Administrative Approval Action

Case File / Name: ASR-0071-2021
DSLC - COMET RALEIGH APARTMENTS

REQUEST: Development of a 21.6 acre/940,958 sf tract, .98 acres/42,831 sf of right-of-way dedication, including .155 acres/6,766 sf on Hartham Park Ave Ext, leaving a net area of 20.463 acres/891,351 sf; zoned RX-4-PK CU. Proposed 224 multi-unit apartment development, 4 buildings (Proposed Building #1 - 61,236 sf; Building #2 - 61,236 sf; Building #3 - 61,236 sf; Building #4 - 61,236 sf & a clubhouse total 5,613 sf) totaling overall gross building area of 250, 557 sf.

**ADMINISTRATIVE SITE REVIEW
COMET RALEIGH APARTMENTS
UTILITY PLAN
2801 FORESTVILLE RD
RALEIGH, NORTH CAROLINA**

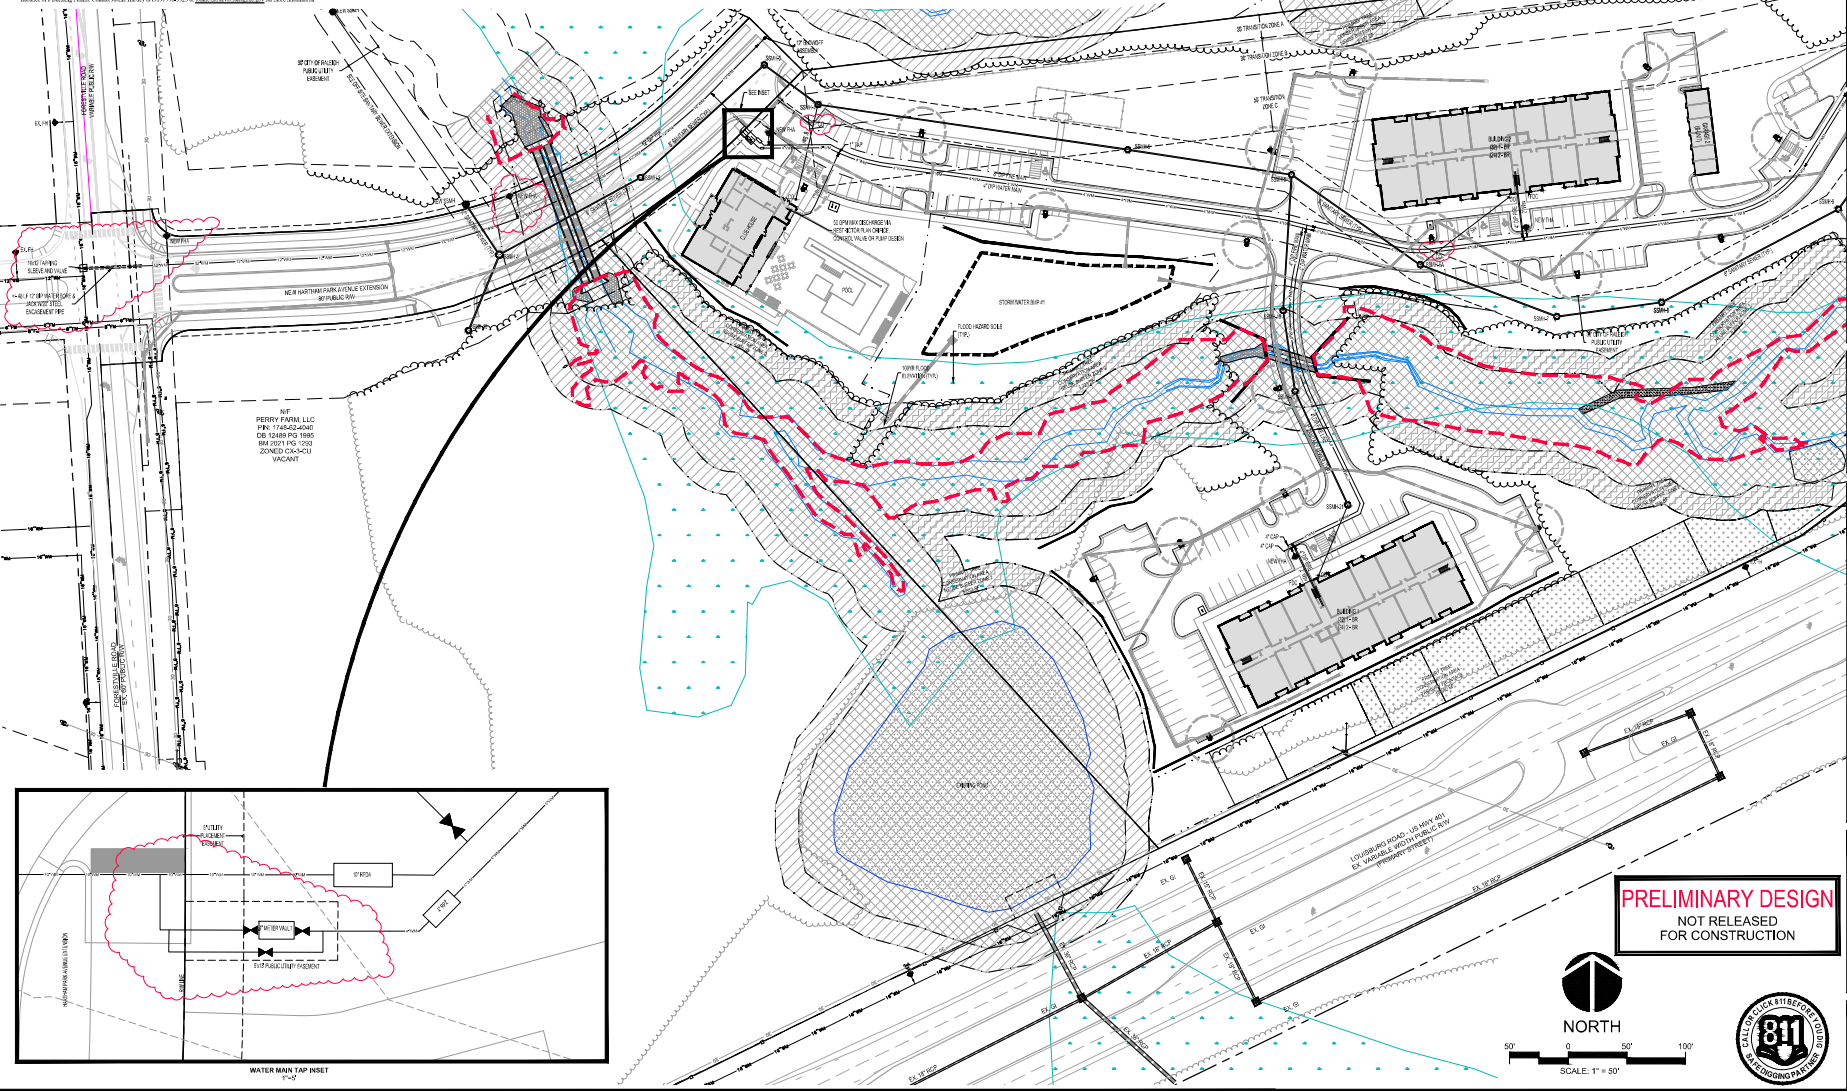
5. A deed shall be recorded prior to concurrent approval for all necessary offsite City of Raleigh Sanitary Sewer Easements to accommodate future sewer line construction.
6. A Downstream Sewer Capacity Study in compliance with the City of Raleigh Public Utilities Department Handbook shall be submitted by the Project Engineer for review and approval.

ADMINISTRATIVE SITE REVIEW
COMET RALEIGH APARTMENTS
2801 FORESTVILLE RD
LANDSCAPE
RALEIGH, NORTH CAROLINA

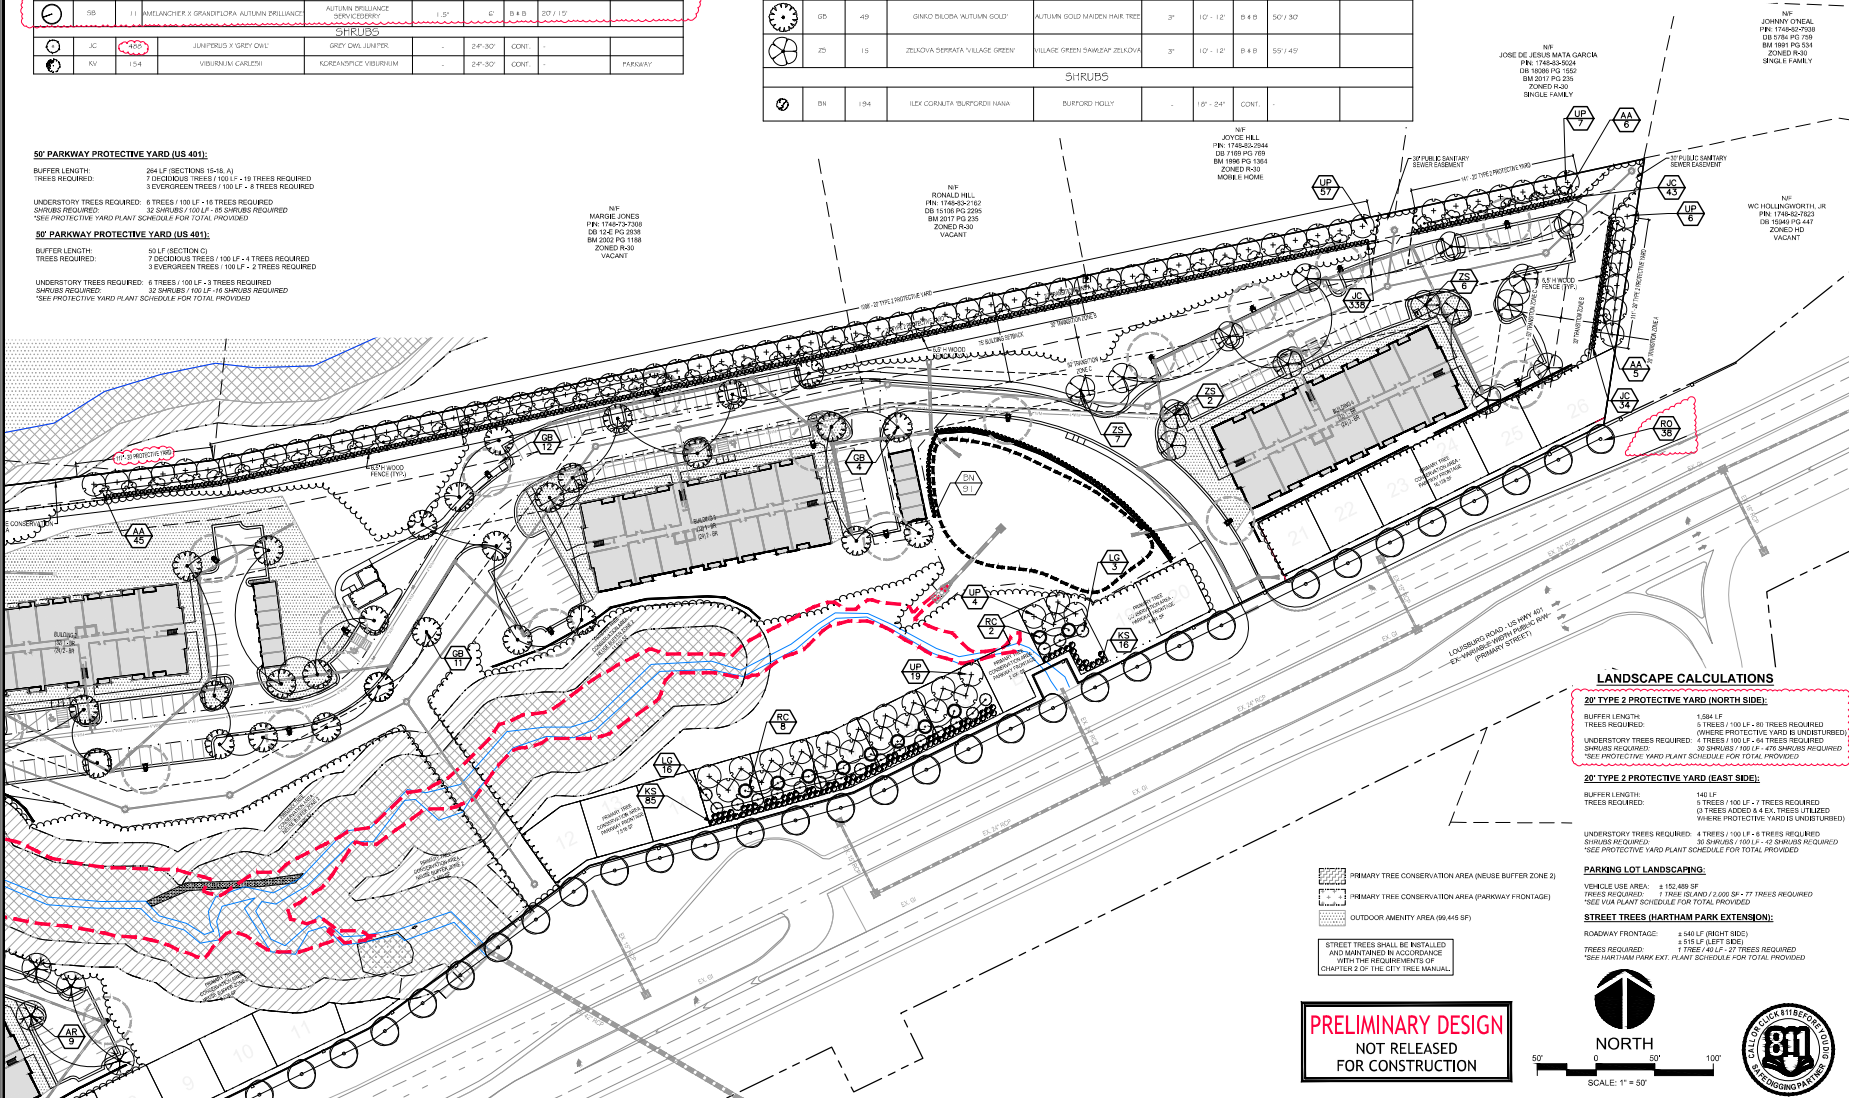
12. Submit a final tree conservation plan that includes metes and bounds descriptions of all tree conservation areas and tree protection fencing as required (UDO 9.1.5).
13. Tree protection fence must be inspected by Urban Forestry staff prior to the issuance of a grading permit.
14. Attach NCDOT planting permit for right of way tree planting along Louisburg Road onto Landscape Plan of Site Permitting Review plan set.

10. A public infrastructure surety for 70 street trees shall be provided to City of Raleigh Transportation – Development Engineering Division (UDO 8.1.3) in the amount of 100% of the improvement cost for the NCDOT portion and 125% of the improvement cost for the City of Raleigh infrastructure.
11. A tree conservation plat shall be recorded with metes and bounds showing the designated tree conservation areas (UDO 9.1).
12. A tree impact permit must be obtained for the approved streetscape tree installation in the right of way. This development proposes 27 street trees along Hartham Park Extension and 49 street trees along Louisburg Road.
